**WASILLA PLANNING COMMISSION
RESOLUTION SERIAL NO. 21-06**

**A RESOLUTION OF THE WASILLA PLANNING COMMISSION APPROVING
CONDITIONAL USE PERMIT NO. 21-04 TO BUILD A 5,000 SQUARE FOOT
COMMERCIAL BUILDING WITH OUTDOOR DINING, LOCATED ON UNIT 3, STEAM
COMMONS CONDOMINIUM PLAT.**

SITE PLAN
1/8" = 1'-0"

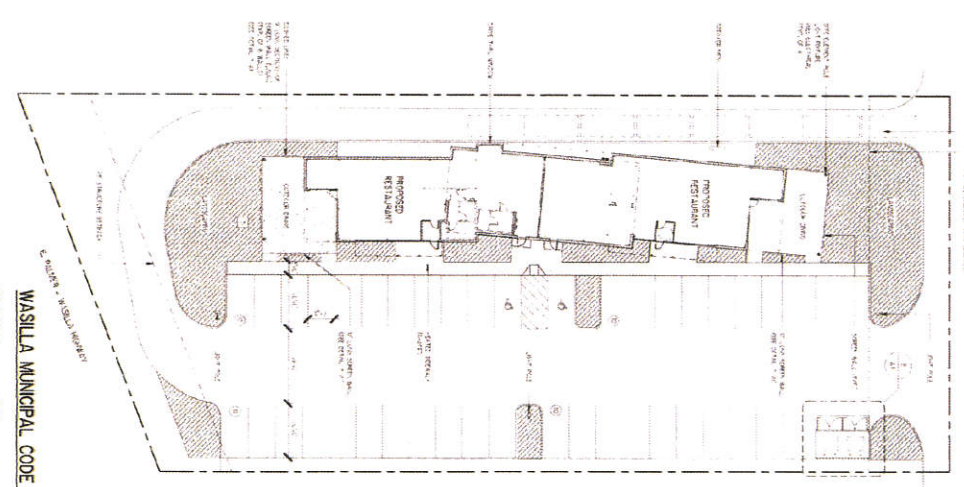
2. Provide survey for Unit 3, Steam Common Condominium showing corners set/located dated within last six months (WMC 16.08.015(C)(3)).
3. Submit updated site plan prior to vertical construction that provides: (a) on-site drainage and retention/detention areas required in WMC 16.05.015(C)(13); (b) snow storage calculations in WMC 16.24.040(D)(9)(b); (c) parking calculations based on WMC 16.24.040(E); and (d) overall plan of the entire lot that identifies Unit 3 along with the required extension and construction of the private easement to the

Finding: This criterion is met. The proposed site plan provides 43 parking spaces (one is a handicap accessible space), which meets the requirement for a restaurant use. Restaurants require one parking space per 150 square feet of gross floor or one parking space per three seats, whichever is greater. This will allow a maximum of 129 indoor/outdoor seats for this building.

Finding: This criterion is not met since the site plan did not provide adequate on-site retention/detention. However, with the condition of approval requiring submittal of a revised site plan providing this information, this criterion is met.

Finding: This criterion is met. Water and sewer are available for the site and the applicant will coordinate with the Public Works department to obtain necessary City permits. A proposed condition of approval requires submittal of an updated site plan that shows drainage directed to on-site retention areas.

LANDSCAPE PLAN
SHEET
L103

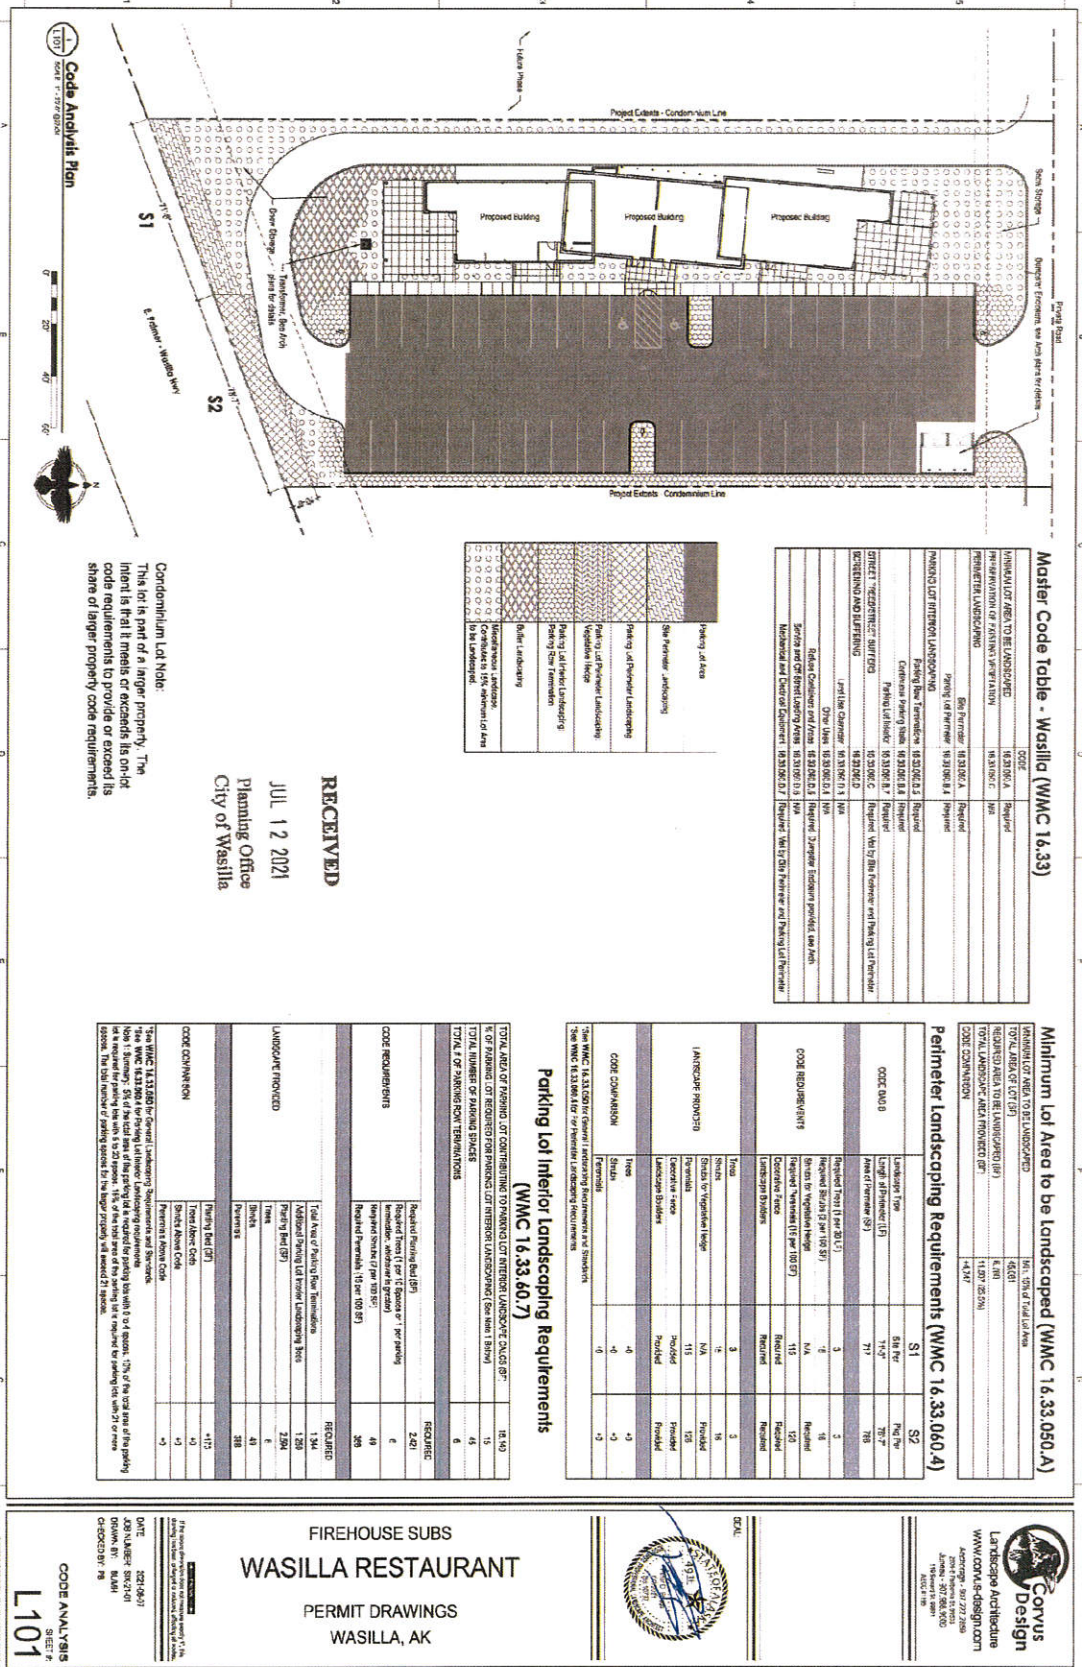
Finding: This criterion will be met with condition of approval to provide an updated landscape plan that meets the requirements in WMC 16.33.

5. Submit required clearing/grading plan (WMC 16.08.015(C)(13)).
6. Submit updated landscape plans prior to vertical construction that meets the following requirements in WMC 16.33: (a) label the dimension and area of the landscaped areas; (b) provide plant diversity; (c) indicates vegetative mulch in perimeter planting bed; and (d) provides hedge along eastern perimeter of parking lot extending from southern boundary to first landscape island to the north. Hedge must be a minimum of three feet tall at time of planting.
